UNITED STATES PATENT AND TRADEMARK OFFICE

APPLICATION NO.	FILING DATE	FIRST NAMED INVENTOR	ATTORNEY DOCKET NO.	CONFIRMATION NO.
10/553,336	11/27/2006	Kenji Nagakawa	10921.363USWO	1215
52835	7590	05/12/2010		
HAMRE, SCHUMANN, MUELLER & LARSON, P.C.				
P.O. BOX 2902				
MINNEAPOLIS, MN 55402-0902				
EXAMINER				
SAKELARIS, SALLY A				
ART UNIT		PAPER NUMBER		
1797				
MAIL DATE		DELIVERY MODE		
05/12/2010		PAPER

Office Action Summary

DETAILED ACTION

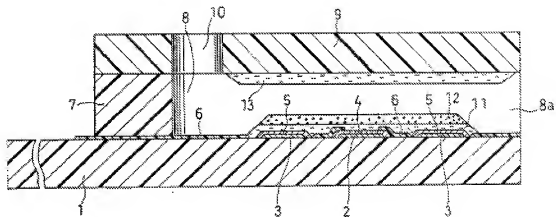
With regard to claims 16 and 18, as can be seen above, Watanabe teaches that the facing distance between (9) and (1) is 0.1 mm which is 100 μ m which is therefore not greater than 300 μ m, 150 μ m, or 100 μ m and not smaller than 30 μ m (Example 2 [0068]).

Watanabe does not teach that the facing distance is no greater than 75 μ m.

It would have been obvious to one of ordinary skill in the art at the time the invention was made to have decreased the size of the facing distance by 25 μ m for the expected benefit of controlling the capillary flow of the sample through the channel and increasing the contact with the reagents below and above the sample and furthermore since where the general conditions of the claim are disclosed in the prior art, discovering the optimum or workable range involves only routine skill in the art.

In order to be responsive to the arguments made by the applicant with regard to the previously applied references however, applicant should note that they are generally arguing limitations either not recited in the claims, or alternatively are characterized by only functional language and not a positive recitation of structure in their claims. For example, in response to applicant's argument that Watanabe fails to disclose that both the first part and the second part of the reagent portion contain the same reagent, Watanabe does teach a first and second portion with reagents loaded on them that further face each other (See (13) and (12) below).

In the above new rejection, it is asserted that it would have been obvious to have loaded the same color-developing reagents of Mochida onto the absorbent pads of (13) and (12) which face each other and which were previously loaded with other reagents as stated above. Therefore applicant's arguments regarding Watanabe failing to disclose that both of the first part and second part of the reagent portion loaded with the same reagent facing each other is not convincing in light of the new rejection in view of Mochida and the obviousness of combining Watanabe in view of Mochida.
